Origination Form
Proposed Revisions to a Standard Plans Index

Originator:	Meyer, Ronald	Index Number:	508-T01
Date:	6/9/2026	Sheet Number(s):	2
E-mail:	Ronald.Meyer@dot.state.fl.us	Index Title:	TRAFFIC CONTROL DEVICES FOR MOVABLE SPAN BRIDGE SIGNALS

FIGURE - F

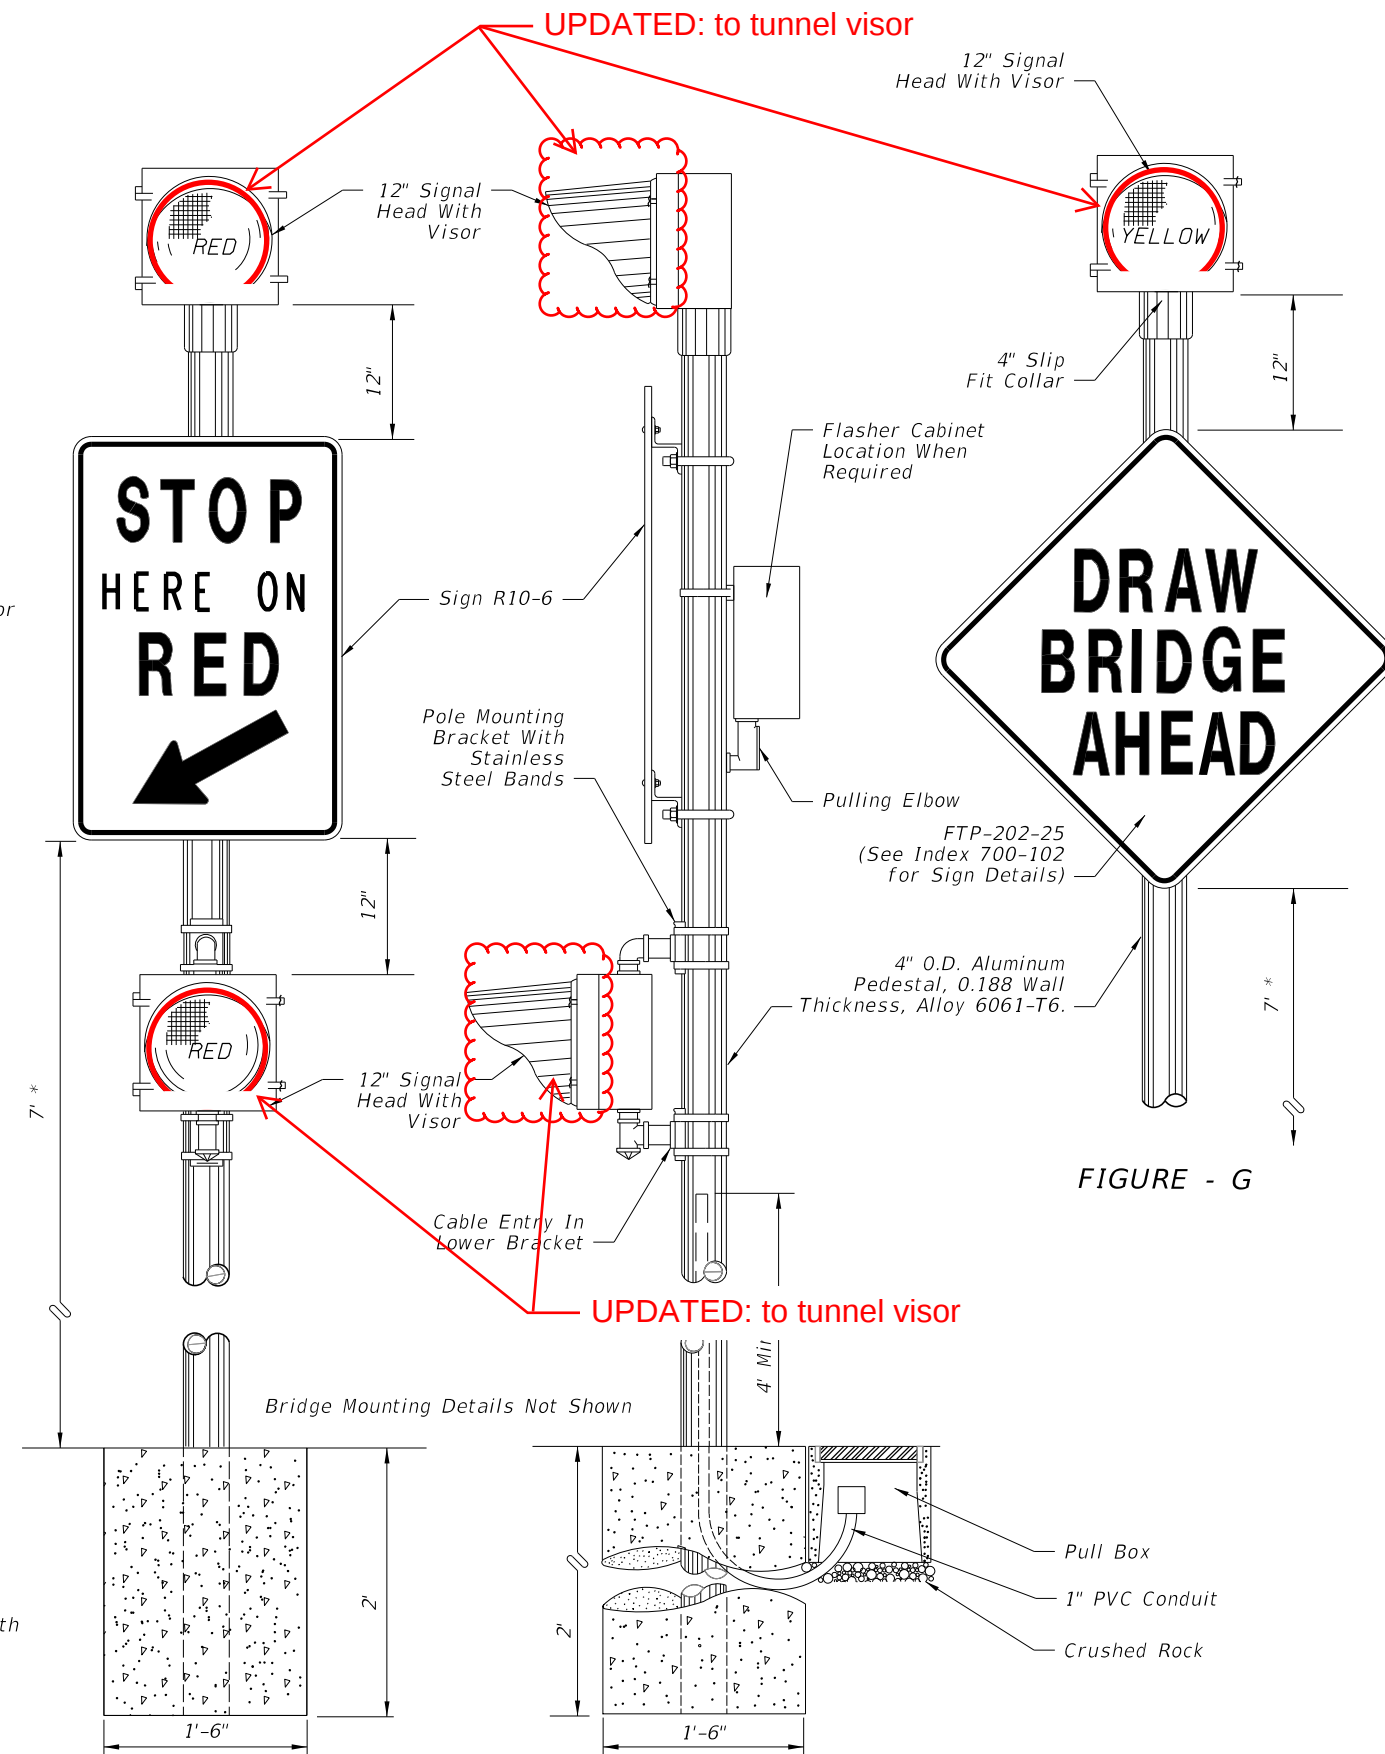
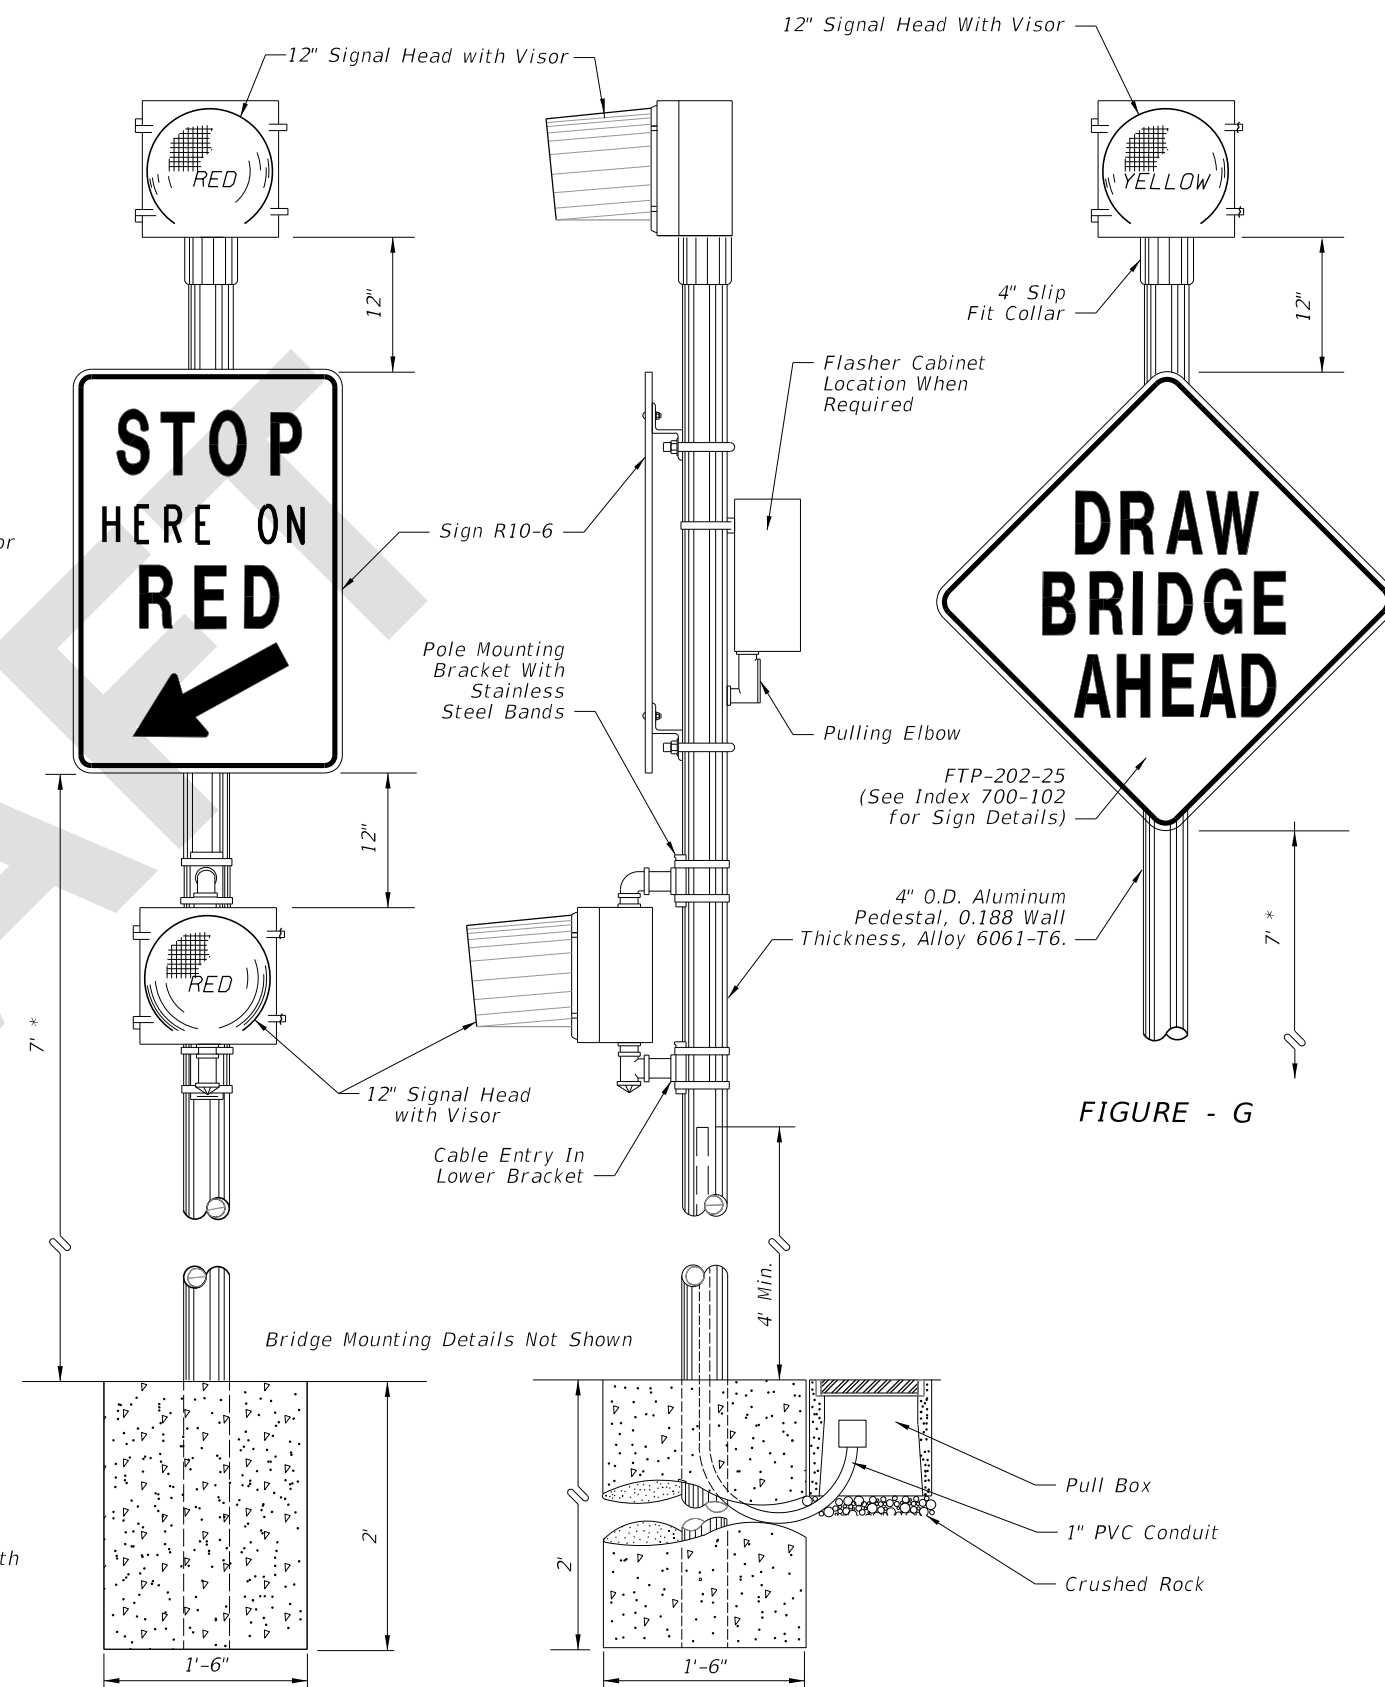
Updated the Signal visor from a Cap type to a Tunnel type in FIGURE - F and FIGURE - G.

The TERL requests that 508-T01 be modified to depict signals with tunnel or full circle visors. Only tunnel or full circle visors are listed on the APL due to requirements for circular traffic signals in sections 650 and 995-4. Signals and beacons typically use tunnel visors due to this specification content as well as depictions of signals and sign beacons throughout other Standard Plans (e.g. 700-120, Sheet 10 of 13 depicting a RR sign with a beacon, etc.).
